General Comments

5.3 Plant Change Process

Figure J-1 – Fire PRA Treatment of Cumulative Risk

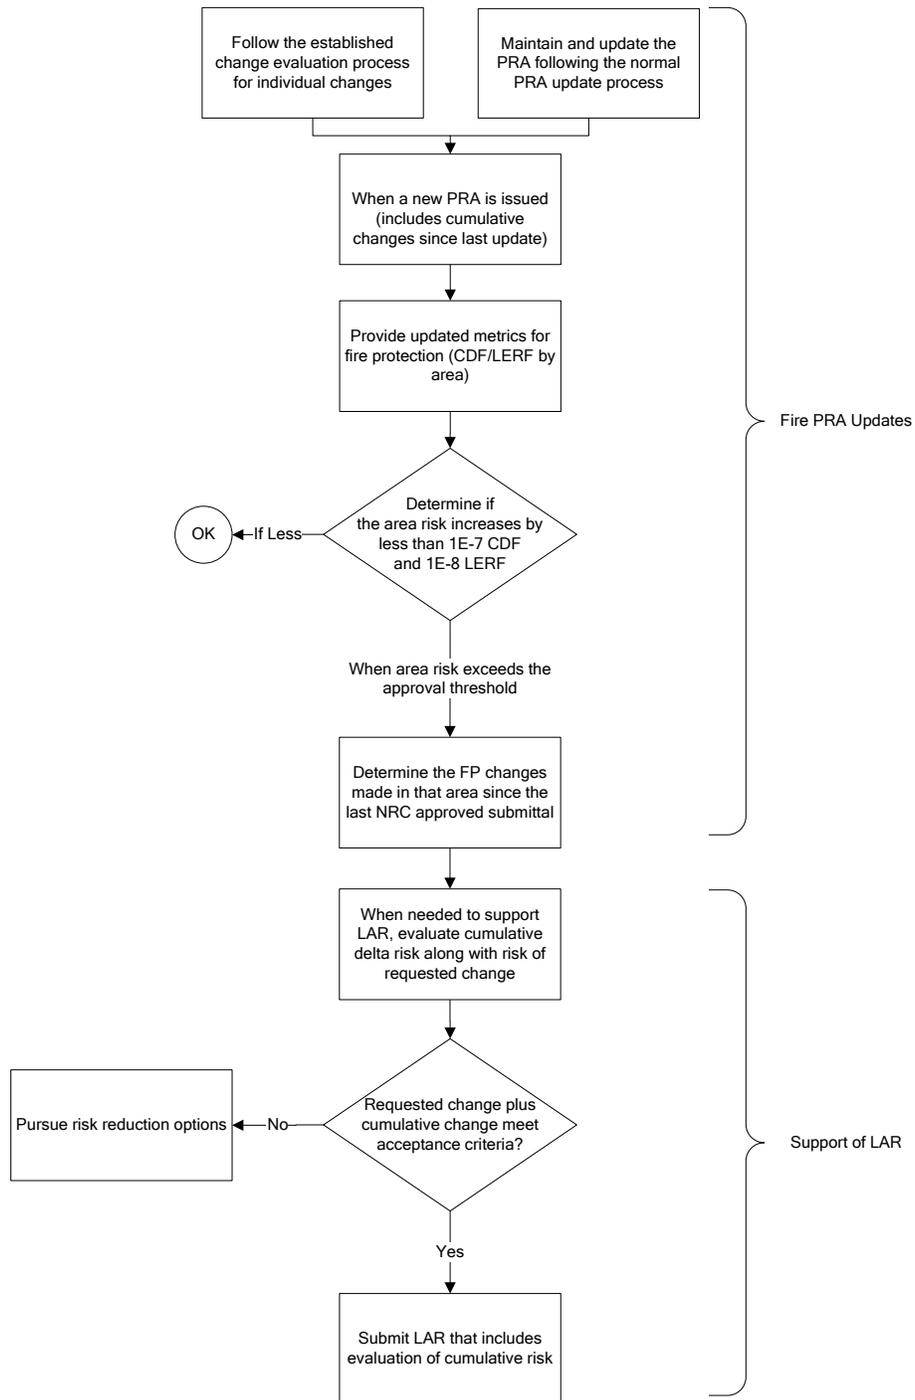
5) The cumulative change in risk in J.6.2 certainly seems to address this complex issue, but the current write-up seems to mix (changes in risk from a change) with (changes in risk following PRA updates). The proposal seems to be:– new changes addressed as they are developed without addressing cumulative, cumulative is addressed during the periodic PRA updates based on changes in fire area risk.

[Yes that was the intent.]
